# Access Compliance Report

## Public Rights-of-Way

Intersection ID: 10033070	Main Street: NORTH_COMMUNITY_HOUSE_RD	Cross Street: N/A	Location: SW
ADA ID: 6E66D3BD7259	Ramp Type: PerpDiag	Initial Pass/Fail: Fail	Overall Compliance: No
Severity Score: 8.75			
Codes/Mitigation Info/Possible Solution		Field Measurements/Component Compliance

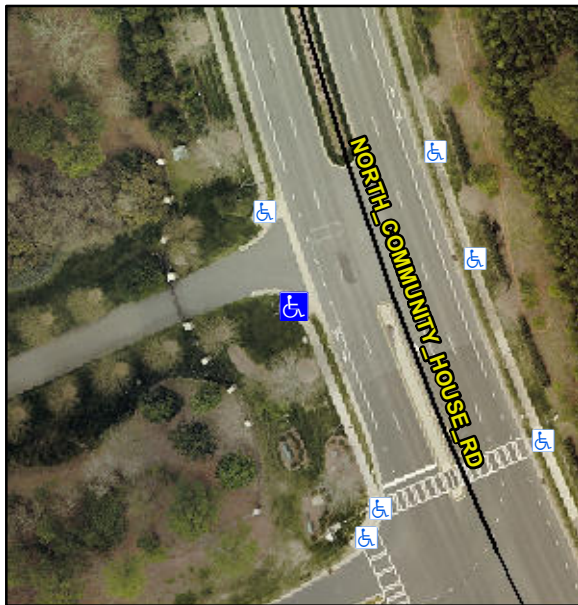
**Not Found, R304.5.1**

Compliance	Description	Data	Compliance	Description	Data
N/A	Ramp Length (in)	108.0	Yes	Ramp Slope (%)	5.1
No	Ramp Width (in)	41.0	Yes	Ramp XSlope (%)	1.6
N/A	Flare Type LT	N/A	N/A	Flare Type RT	N/A
N/A	Flare Slope LT (%)	N/A	N/A	Flare Slope RT (%)	N/A
N/A	Flare Traversable LT?	N/A	N/A	Flare Traversable RT?	N/A
N/A	Landing Length (in)	N/A	N/A	DWS Provided?	N/A
N/A	Landing Width (in)	N/A	N/A	DWS Contrast?	N/A
N/A	Landing Slope (%)	N/A	N/A	DWS Length (in)	N/A
N/A	Landing X Slope (%)	N/A	N/A	DWS Full Width?	N/A
N/A	Landing Curb? (Y/N)	N/A	N/A	DWS Offset (in)	N/A
N/A	Shared Landing?	N/A			
N/A	Gutter Ponding?	N/A	N/A	Gutter Slope (%)	N/A
N/A	Gutter Lip Ht (in)	N/A	N/A	Gutter X Slope (%)	N/A
N/A	Painted X Walk1?	No	N/A	Painted X Walk2?	No
	X Walk 1 Direction	To NE		X Walk 2 Direction	To NW
N/A	X Walk 1 Width (in)	N/A	N/A	X Walk 2 Width (in)	N/A
	X Walk 1 Slope (%)	4.8		X Walk 2 Slope (%)	2.4
	X Walk 1 X Slope (%)	0.4		X Walk 2 X Slope (%)	1.6

**Remove & Replace Curb Ramp With Two New Directional Ramps or Equivalent.**
